COMMUNITY DEVELOPMENT DEPARTMENT

SUBJECT: FP-2021-0042
Apex Southeast No. 3

Final plat consisting of 70 single-family residential buildable lots and 11 common lots on 19.66 acres of land in the R-8 zoning district.

B. Final Plat (dated: 7/16/21)

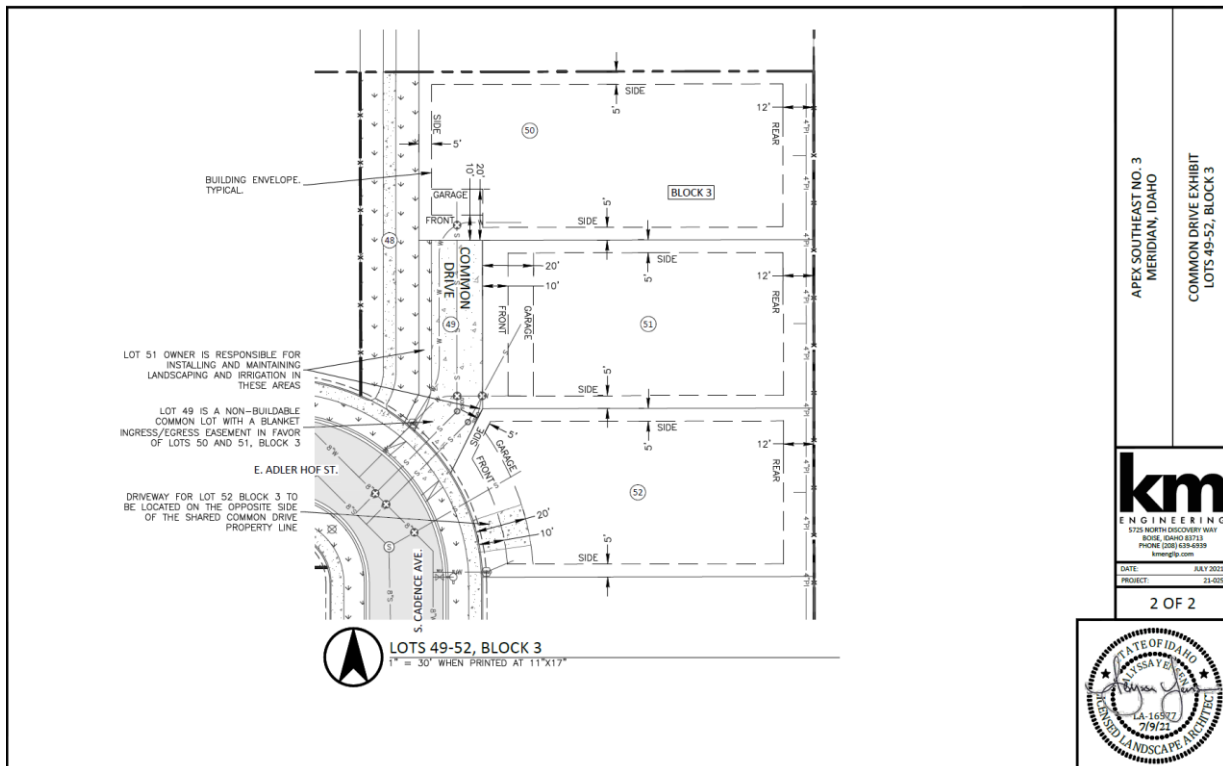
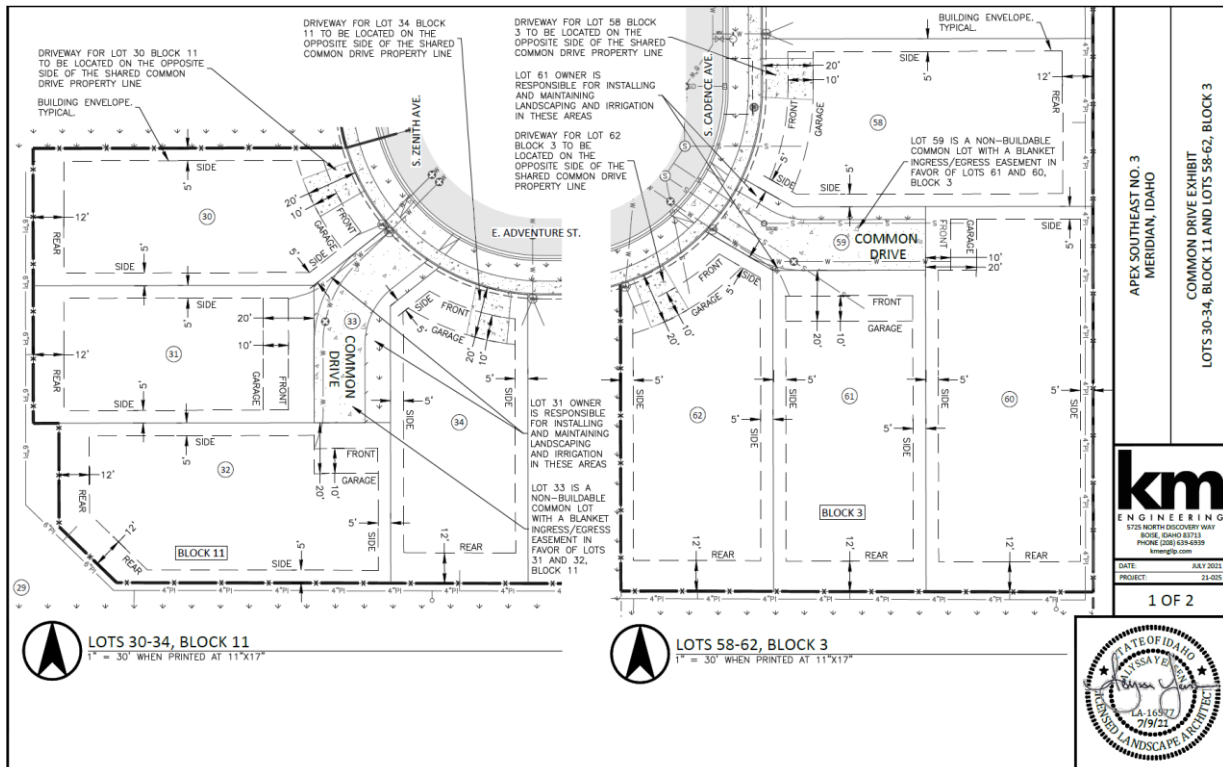
References (Sheet 1):

- a. R1. – Include the Book and Page numbers of the Apex Southeast Subdivision No. 1 plat.
- b. R2. – Include the Book and Page numbers of the Apex Southeast Subdivision No. 2 plat.

Notes (Sheet 3):

- c. Note #5: “. . . Lot ~~44~~7, Block 13 . . .” “. . . owned and maintained by the ~~operator or assigns~~ homeowner's association . . .”
- d. Note #6: “. . . to provide access for Lots ~~51-53~~ 50 and 51, Block 3, ~~Lot 58 and Lots 60-62~~ 60 and 61, Block 3, Lots ~~30 31 and 32 and Lot 34~~, Block 11, respectively. ~~Said 6.~~ Lot 49, Block 3, Lot 59, Block 3, Lot 33, Block 11, shall be owned by the Apex Southeast Homeowner's Association, Inc., or assigns, and the owners of the lots that benefit from the common drives shall maintain, repair and/or replace said common drives at their own cost and expense. ~~Said 6,~~ Lot 49, Block 3. . .”

- e. Note #10: Include the recorded instrument number of the ACHD landscape license agreement.
- f. Note #11: Include the recorded instrument number of the ACHD public right-of-way (sidewalk) easement.

- g. Note #12: “Direct lot or parcel access to S. Locust Grove Rd. and E. Via Roberto St. is prohibited. . .”
- h. Note #15: “. . . Lot ~~44~~7, Block 13, are servient to. . .”

- i. Note #16: Include the recorded instrument number of the CC&R's.

Graphic Depictions:

- j. Sheet 1: Include the CP&F No. at the southeast corner of the site.
- k. Sheet 3: Include the recorded instrument number of the ACHD temporary turnaround easement.
- l. Sheet 4: Include the recorded instrument number of the ACHD permanent easement on Lot 7, Block 13.

A copy of the revised plat shall be submitted with the final plat for City Engineer signature.
